ATTACHMENT A–Assessment Findings

Attachment A outlines the assessment findings and is based on the justification matters as set out by the Department of Planning & Environment.

Figure 1: Recommended pedestrian link improvements

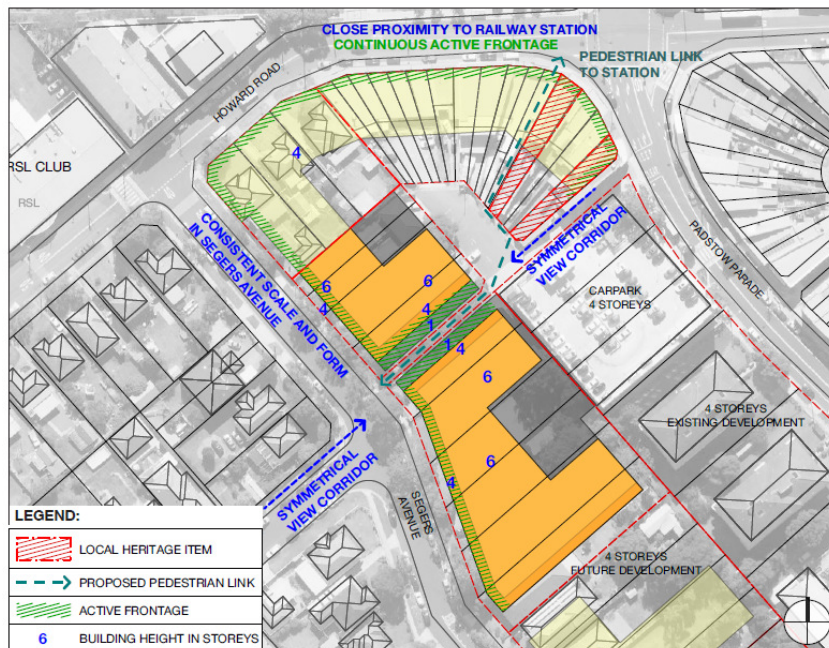
In relation to supporting infrastructure, the urban design peer review supports the proposed widening of the Council lane (known as the Padstow Pathway at 5C Segers Avenue) as it has the potential to link the Padstow Park Public School to the railway station with an attractive, active and largely car-free pedestrian link, subject to:

- Widening the lane from 3 metres to 6 metres at street level.
- Requiring continuous active retail frontages along the lane to provide pedestrian amenity and safety.
- Providing a pedestrian crossing (at the Gloucester Street intersection) to contribute to a safe journey from the school to the railway station.
